## City Commission

### 4311 Ponce (4311 Ponce de Leon Blvd)

Mixed Use Site Plan Review  
December 16, 2014

## West Elevation (Ponce de Leon Blvd)

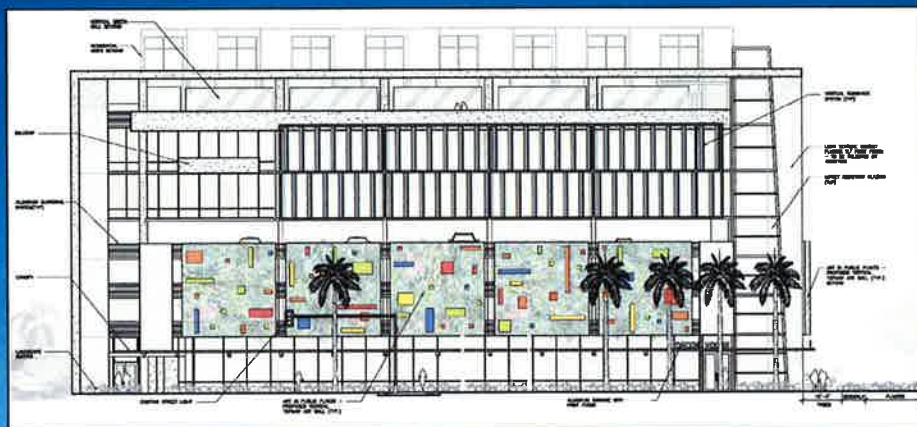
The proposed Application **does not** comply with Section 4-201.E for mixed-use projects:

1. Provide **10' foot front setback** (Ponce de Leon) for building over 45' in height (0' provided for building height of 93'-7"); or
2. To reduce required front setback, provide **10' foot stepback** for building exceeding 45' in height on **all sides** (0' provided)

## North Elevation (Interior Side)

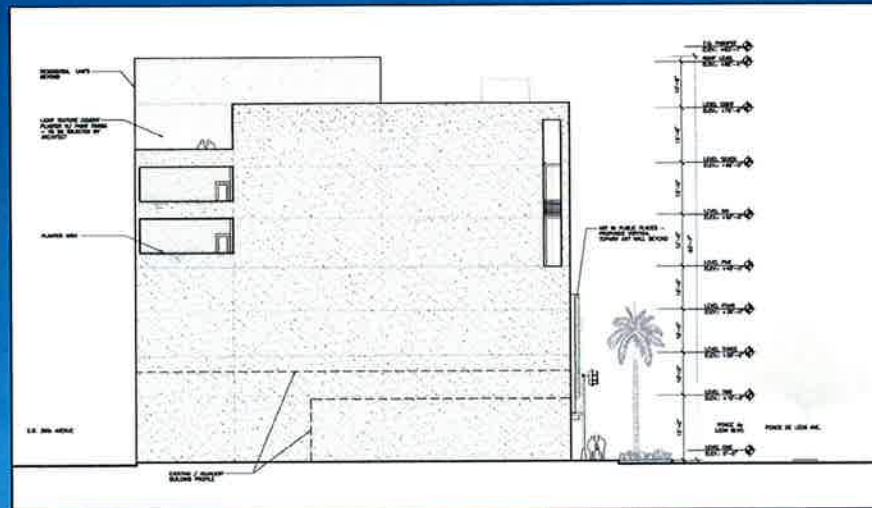
Type	Required*	Proposed
Front stepback (Ponce de Leon Blvd)	0' up to 45' and 10' over 45' bldg. height	Complies for habitable space only
Side street stepback (San Lorenzo Ave)	0' up to 45' and 10' over 45' bldg. height	None - Does not comply
Interior side stepback (north)	0' up to 45' and 10' over 45' bldg. height	None - Does not comply
Rear stepback (SW 39 <sup>th</sup> Ave)	0' up to 45' and 10' over 45' bldg. height	None - Does not comply
